Origination Form
Proposed Revisions to a Standard Plans Index

Originator:	Ryan Gray	Index Number:	110-200
Date:	4/16/2026	Sheet Number(s):	1 thru 3
E-mail:	Ryan.gray@dot.state.fl.us	Index Title:	Mailboxes

Summary of the changes:

Sheet 1: CORRECTED General Notes regarding some measurements, external references, style. CHANGED contents of General Notes by moving some to Specs and/or SPI (Notes 3, 4, 11, and 12). ADDED isometric view of complete mailbox assembly;
Sheet 2: CHANGED post mounting details for flanged channel. ADDED pipe and wood post mounting details and views. DELETED platform, adapter plate, bracket, spacer, and elevation details. UPDATED post, hardware, and attachment details;
Sheet 3: UPDATED platform, shelf, bracket, elevation view, and anti-twist plate details. DELETED pipe post and wood post views. ADDED isometric views for platform, shelf, bracket, and plate. CORRECTED measurements in Elevation Detail.

LAST REVISION	DESCRIPTION:	FDOT	FY 2027-28 STANDARD PLANS	MAILBOXES	INDEX	SHEET
11/01/17	11/1/26				110-200	1 of 3

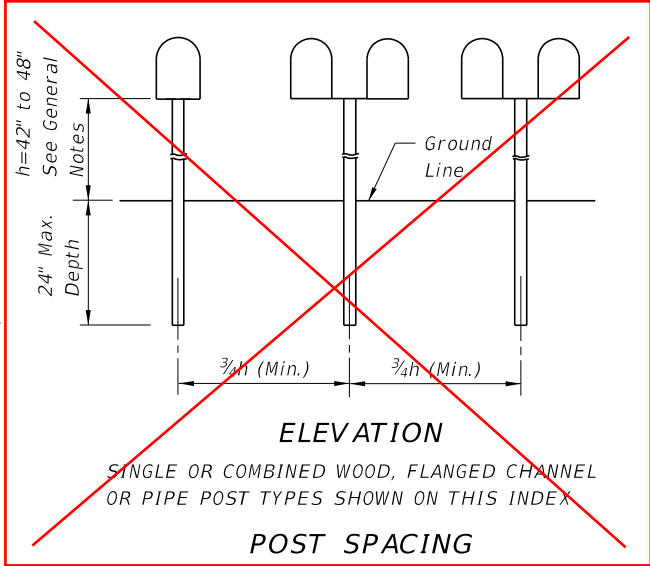
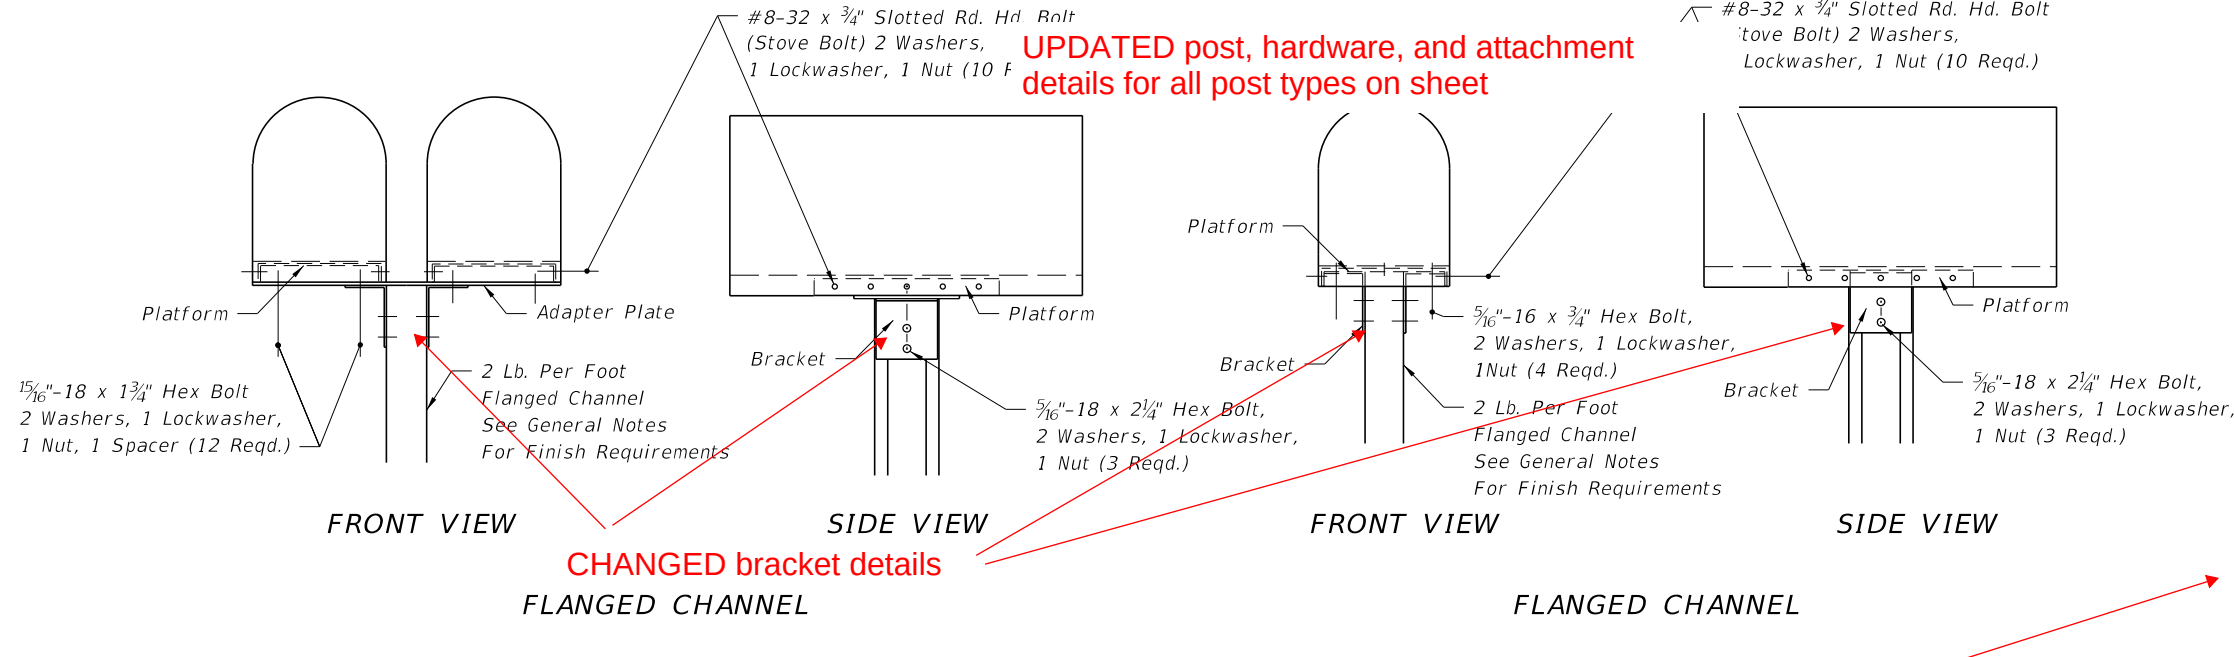
Moved to Standard Specifications or SPI

41" and 45"

CORRECTED & CHANGED

ADDED Iso View of Mailbox Assembly

Support Post Mounting Details

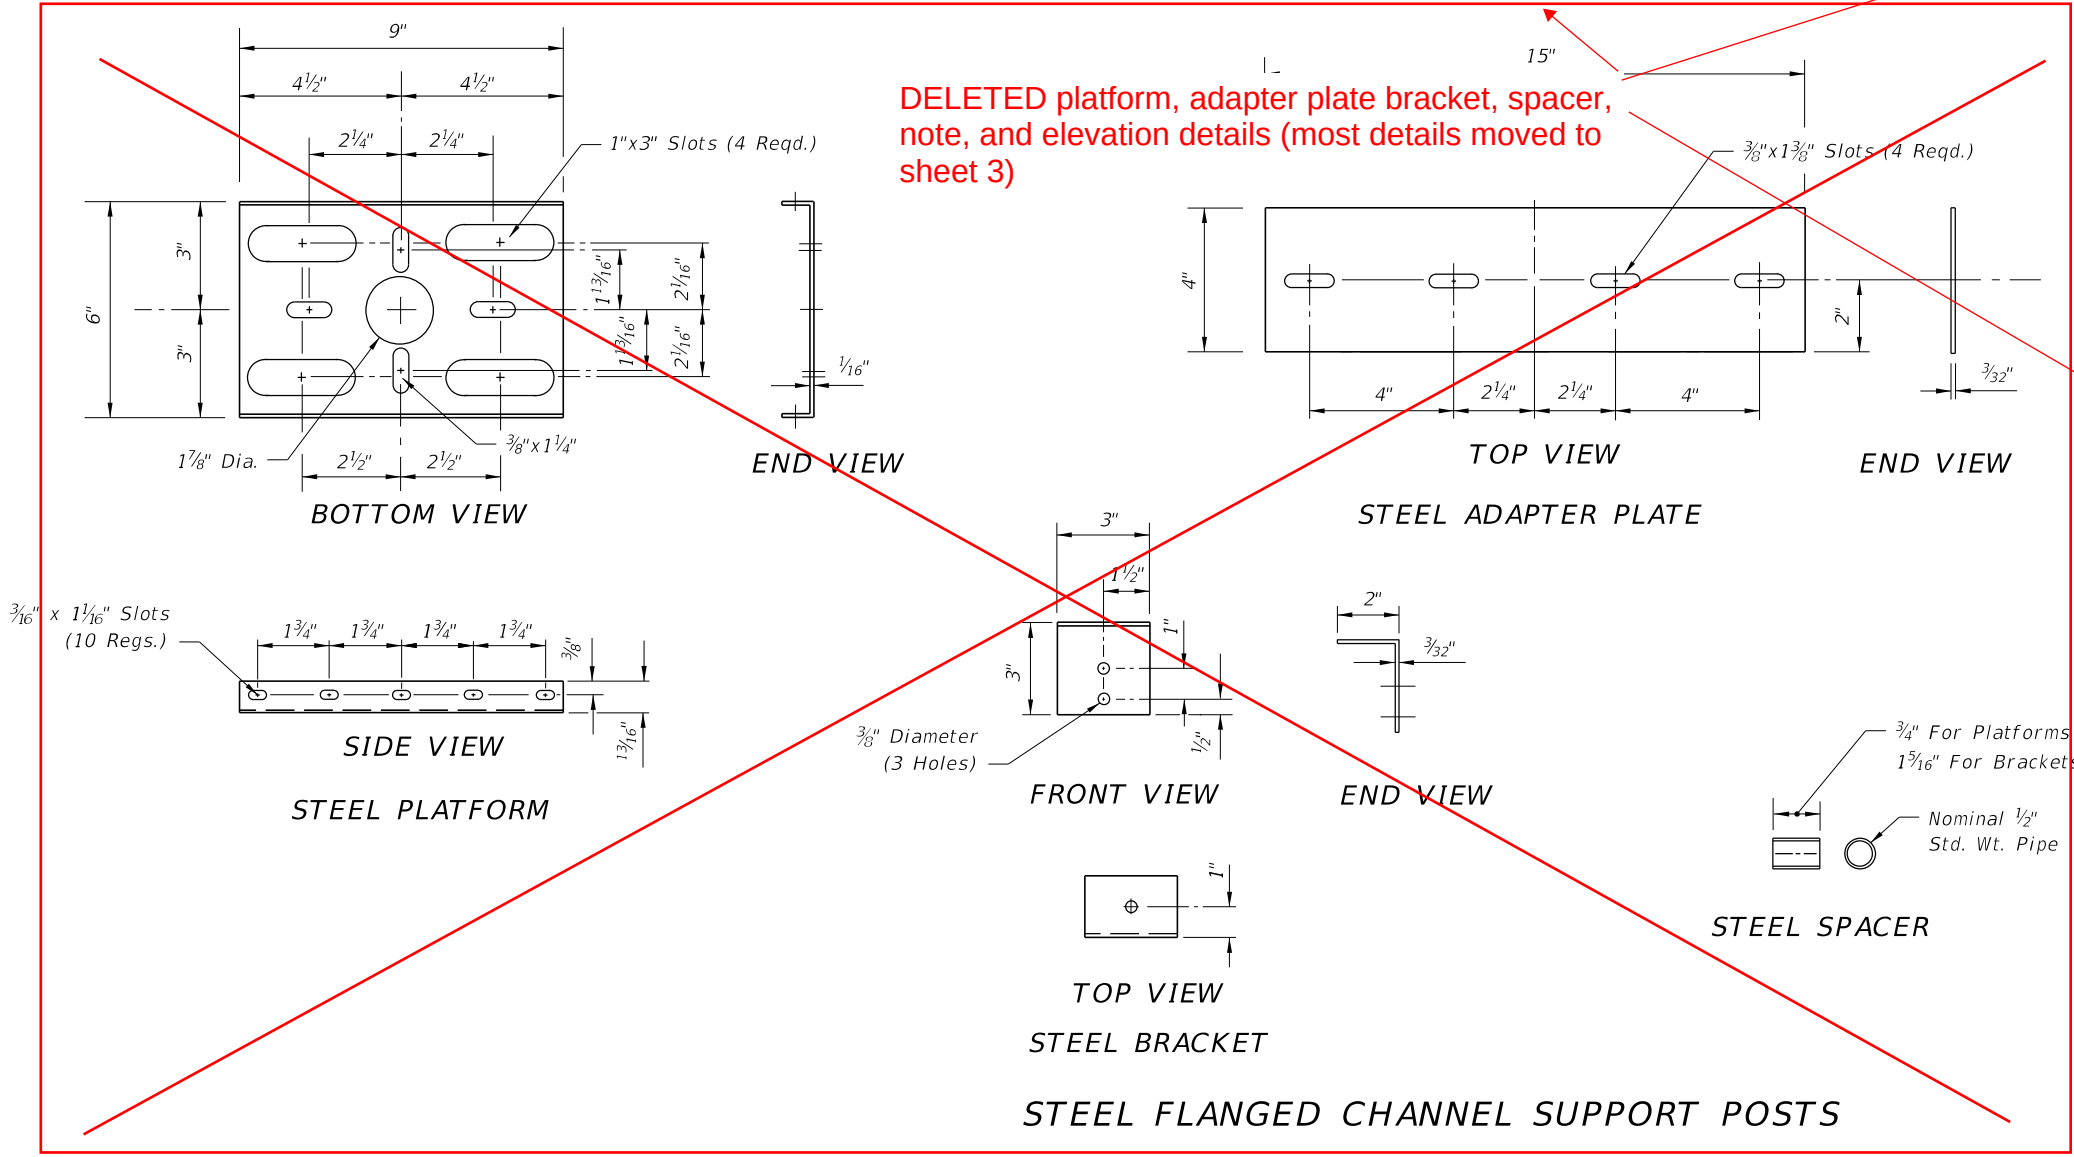
ADDED Steel Pipe Support Post details

ADDED Wood Support Post details

DELETED platform, adapter plate bracket, spacer, note, and elevation details (most details moved to sheet 3)
